RE – Yass Valley Wind Farm Preferred Project Report response (our ref. 4743)

ISSUES AND APPROACH OVERVIEW

1 CLARIFICATION OF ISSUES / DISCREPANCIES RAISED IN OEH SUBMISSION

Figure 3-1 Example of resolution used to count tree canopies. Inner circle radius = 50m. Outer circle radius = 100m.

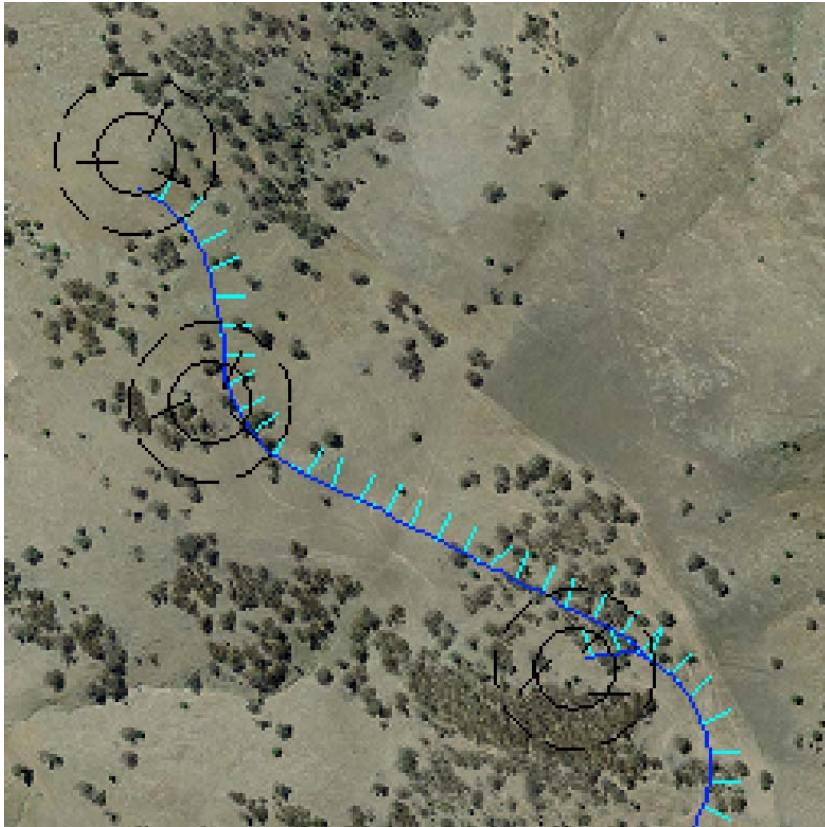
- Using aerial imagery of the final layout, the number of tree canopies were counted:
 - within 50m of a turbine
 - within 100m of a turbine
 - on the transmission line (trees directly on the line, no buffer).
- To estimate the percentage of trees that may have hollows, hollow-bearing tree inventories completed in 2009 for six turbine sites at Coppabella were used. The inventories were completed in areas with high hollow-bearing tree density; Clusters 6, 7 and 10. (The Additional Survey at Coppabella Hills targeting Barking Owl, Squirrel Glider and Bush Stone Curlew is included as Appendix G of the SER). The coordinates of the turbine location and all hollow-bearing trees within 50m allowed for an accurate count of hollow-bearing trees. Counts of total canopies for these areas was done with reference to the aerial imagery.

It is difficult to obtain a reliable count in dense woodland using aerial imagery. Areas of mature woodland and dense regrowth would appear the same on the aerial. In these cases, an average canopy size for the area was used to estimate tree canopy number.

Table 3-2 Six reference sites where all hollow-bearing trees within 50m of a turbine had been GPSed were used to provide a correction factor (percentage of trees that bear hollows) for the broader site. Green dot = turbine centre. Red dot = hollow bearing tree.

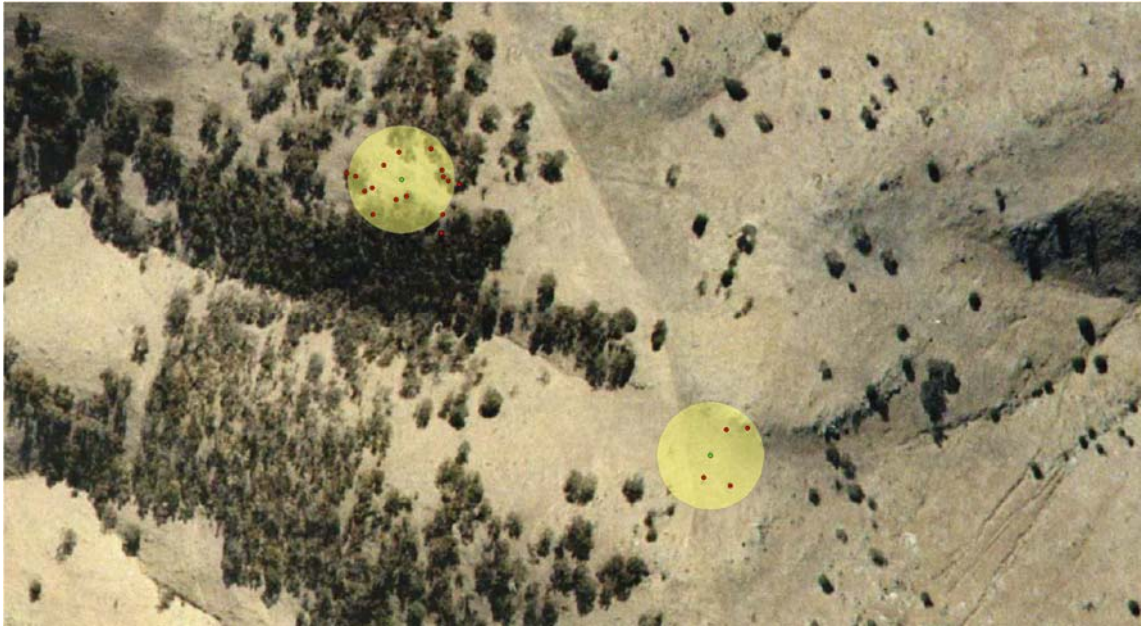
Hollow-bearing tree inventories completed in 2009 for six turbine sites at Coppabella were compared to total tree canopy counts (using aerial imagery) for these same locations. On average 46% of trees were found to bear hollows, across these six locations. It is noted that, as these sites were selected on the basis of proximity to areas of high hollow-bearing tree density, that the average provides a conservative estimate of the potential for trees to bear hollows for the broader site.
